To: Regional Managers/Regional Engineers
From:  Robert Ball, Deputy Director of Design and Construction
CC: Ofelia Alcantara, Bruce Armistead, Eric Scotson, RDP Task Leads
Date: May 18, 2016
Subject: Notice to Designers No. 11 - Automatic Train Control (ATC) Site Requirements

This memorandum establishes the revised guidelines for the Regional Teams to follow in the Preliminary Engineering Design with respect to Automatic Train Control (ATC) sites.

This Notice to Designer rectifies and supplements TM 3.3.2 ATC Site Requirements, Rev. 0.

CONTRACT NO.
 13259
 DRAWING NO.
 TM-3.3.2-AA
 SCALE
 NO SCALE
 SHEET NO.

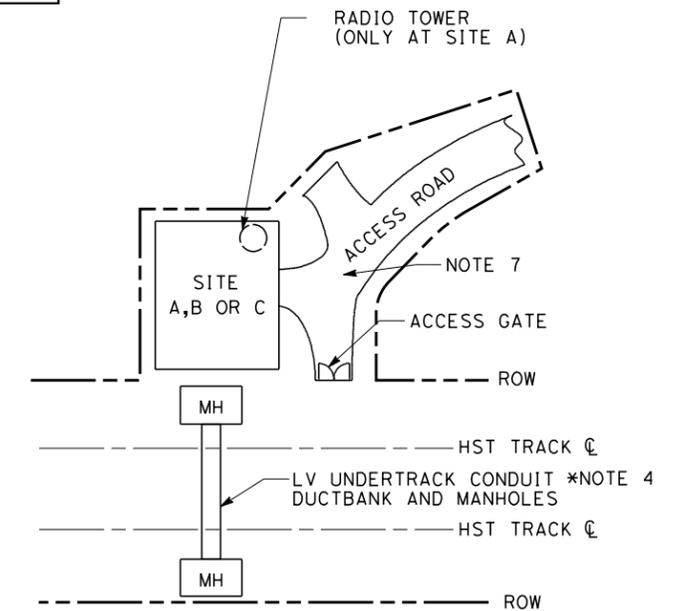
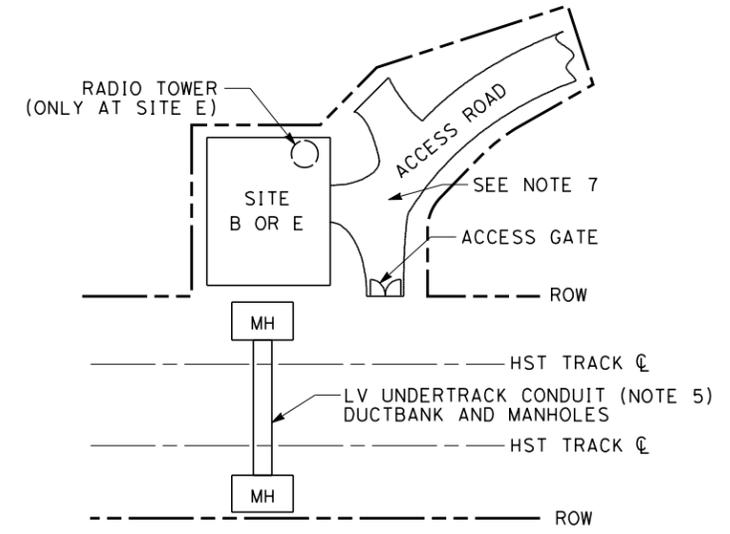
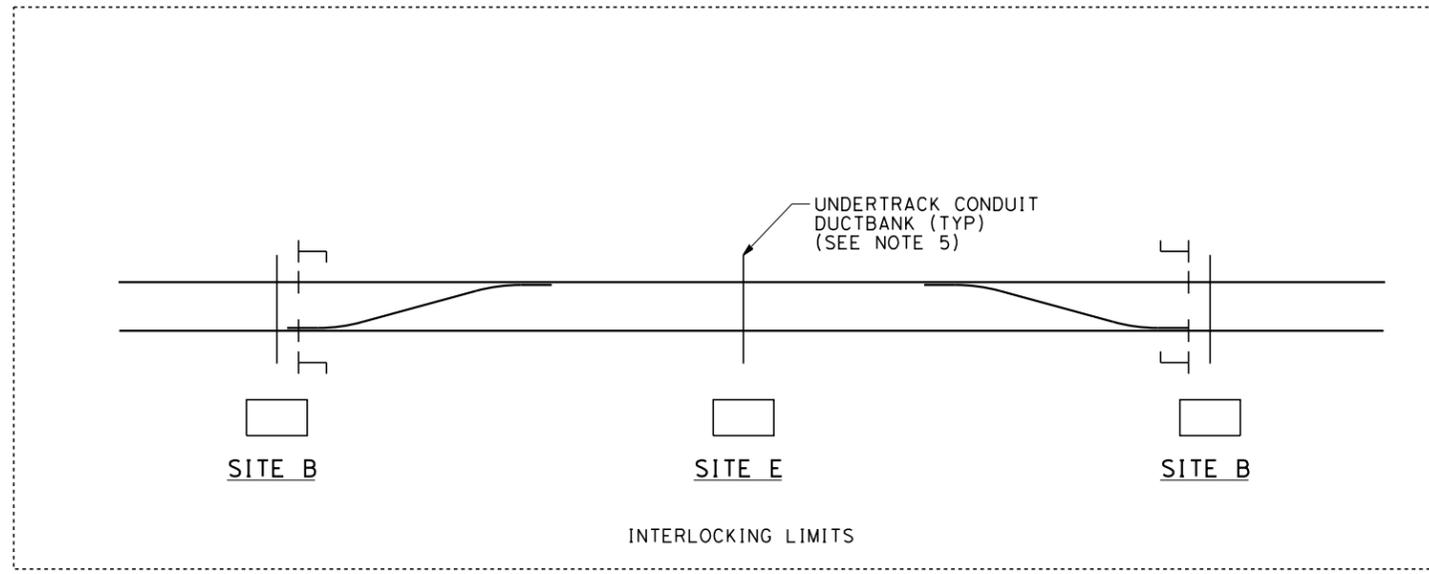
1. Supersede TM drawings (TM 3.3.2-A and TM 3.3.2-B) with the attached TM drawings:
 - TM 3.3.2-AA
 - TM 3.3.2-BB
 - TM 3.3.2-CC
 - TM 3.3.2-DD
2. Increase size of ATC sites:
 - Site A: from 45' x 25' to 70' x 35'
 - Site B: from 30 x 25' to 30' x 35'
 - Site C: from 35' x 25' to 35' x 35'
3. Modified/Added ATC sites:
 - Site AA: 90' x 35'.
 - At the Wye junction, master interlocking house changes from Site A to Site AA.
 - Site D: 100' x 65'.
 - Per TM 3.3.2-CC, provide a nominal distance of 7.5 miles between:
 1. Two adjacent site D's
 2. Station Train Control and Communications (TCC) room and adjacent Site D
 3. Adjacent Site D and Site E (at a universal crossover)
 - Site E: 110' x 65'.
 - At universal crossovers, master interlocking house changes from Site A to Site E
